Subject: CC2035 testimony--Save Mt. Hood views from Salmon Springs and Vista Bridge; return Vista Bridge to a view corridor; reduce heights in historic districts

Figure 16: View of Central City and Mt Hood from SW15 – Proposed Bonus Heights

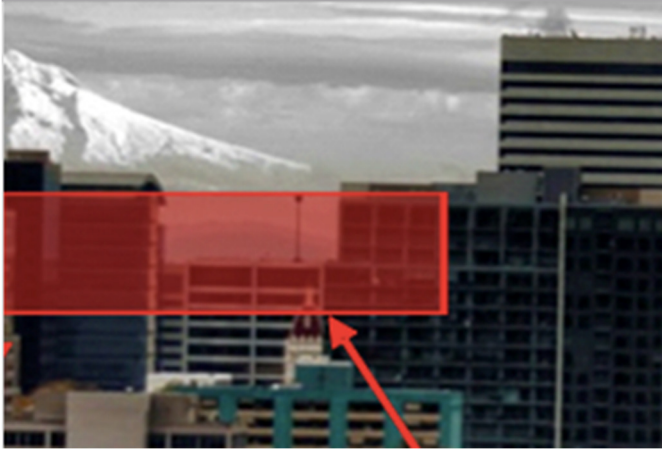
For the same reason, I hope you **protect the 1000' of timberline in the view corridor from the Vista Bridge to Mt. Hood**. When City Council protected this view in 1991, they made a big deal out of protecting 1000' of timberline because of the importance of showing the contrast between the snowcap and the timberline—they understood that this is what makes the view striking. The many residents who testified on this are only asking for a slight modification in heights.

Here's where the heights will need to be slightly modified to protect the current view of 1000' of timberline:
